CORRECTIONS AND CLARIFICATIONS TO VM0042 METHODOLOGY FOR IMPROVED AGRICULTURAL LAND MANAGEMENT, V2.0

Publication date: 22 January 2024

This document provides corrections and clarifications applicable to *VM0042 Methodology for Improved Agricultural Land Management, v2.0*. Such corrections and clarifications are effective on their issuance date. Project proponents and validation/verification bodies (VVBs) shall apply and interpret *VM0042, v2.0* consistent with the clarifications set out in this document.

Figure 1: Examples of defined quantification units and strata

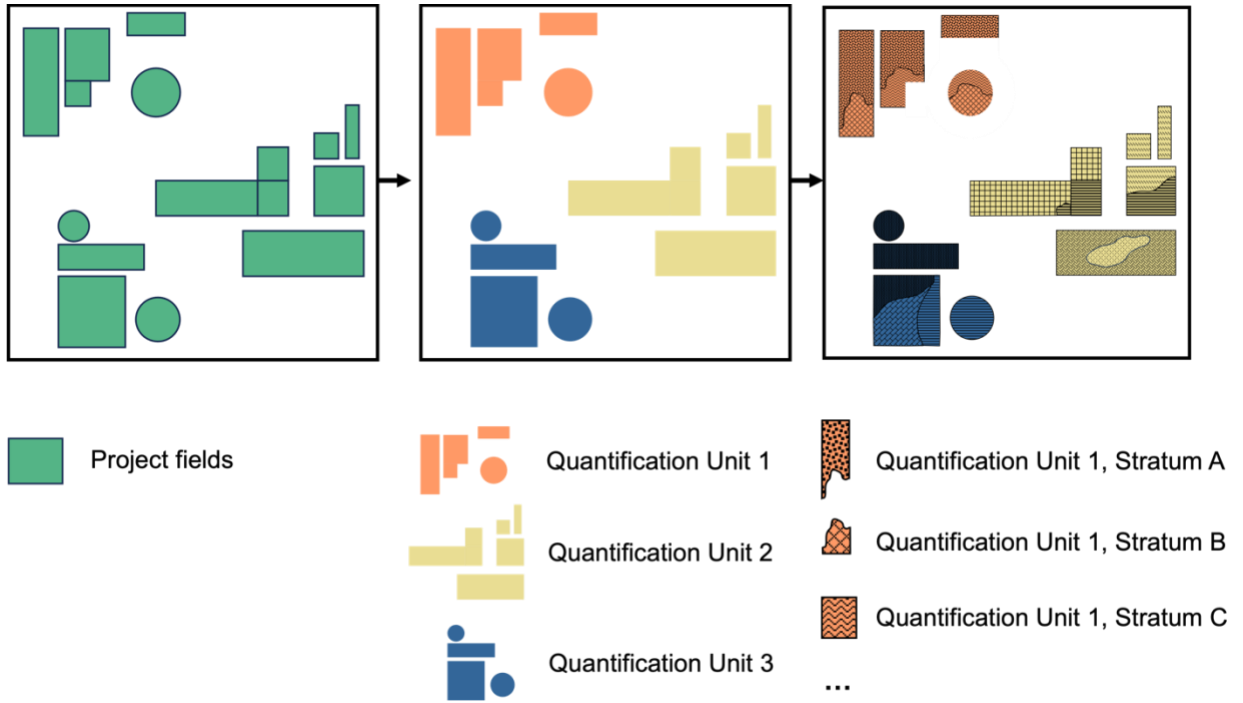
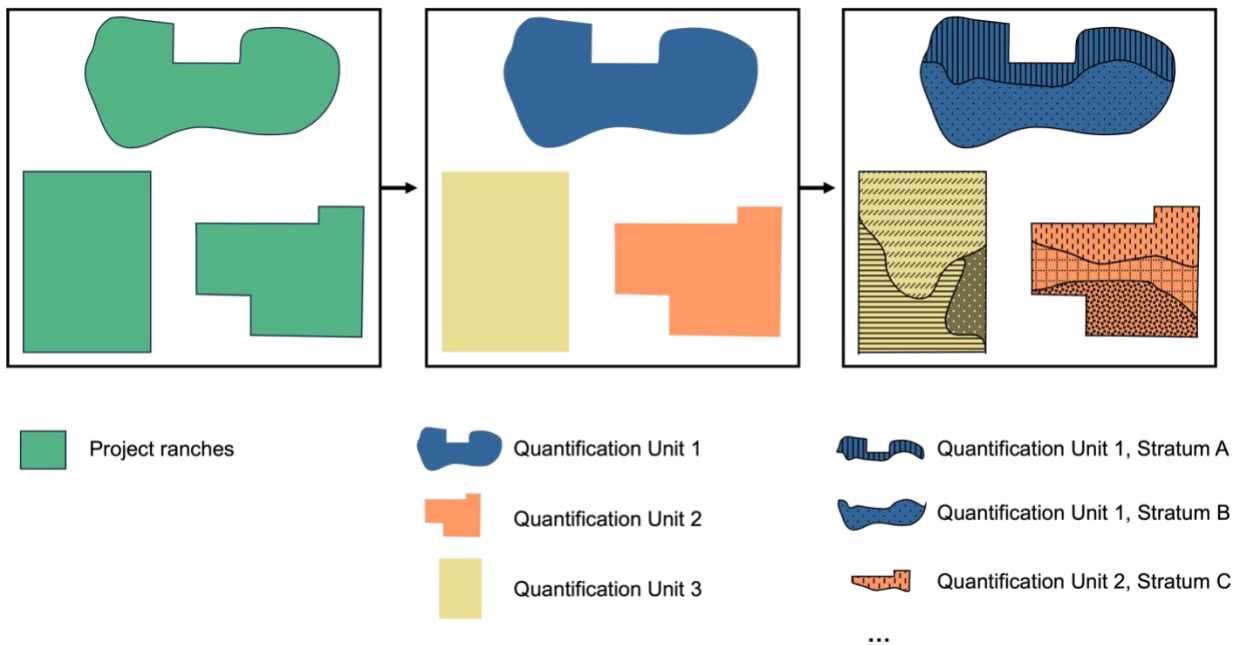
Figure 2 shows two examples of defining quantification units and strata. Random samples should be taken in each stratum.

Enhance clarity around the two terms “Quantification unit” (previously “Sample unit”) and “Stratum,” which are essential for designing sampling and quantification strategies as part of project monitoring, reporting and verification (MRV).

Each quantification unit within the project area must be divided into homogenous strata based on factors influencing SOC stock distribution. In a staged (i.e., hierarchical, nested) design, strata should be generated at the lowest level of quantification unit (see Appendix 6 for an example). Thus, if a sampling design establishes primary and secondary quantification units, strata should be generated as a subset of each secondary quantification unit. The aim of stratifying each quantification unit is to capture SOC stock variability more accurately. Depending on the size of the agricultural fields or paddocks, strata may span numerous fields/paddocks, or one field/paddock may be divided into several strata.

Summary

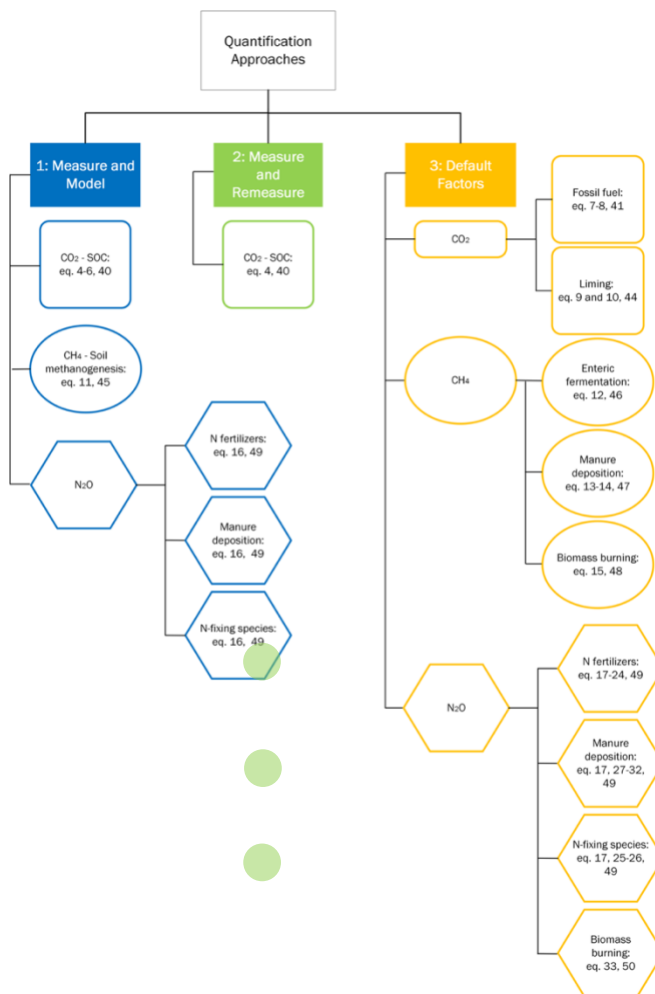
Added subsection title “Summary” for greater clarity on the section’s structure and corrected reference to Equation 49 for N₂O emissions following Quantification Approach 1 in Figure 1.

Figure 1 summarizes which equations are to be applied to each GHG flux depending on the selected quantification approach (see also **Table 2**).
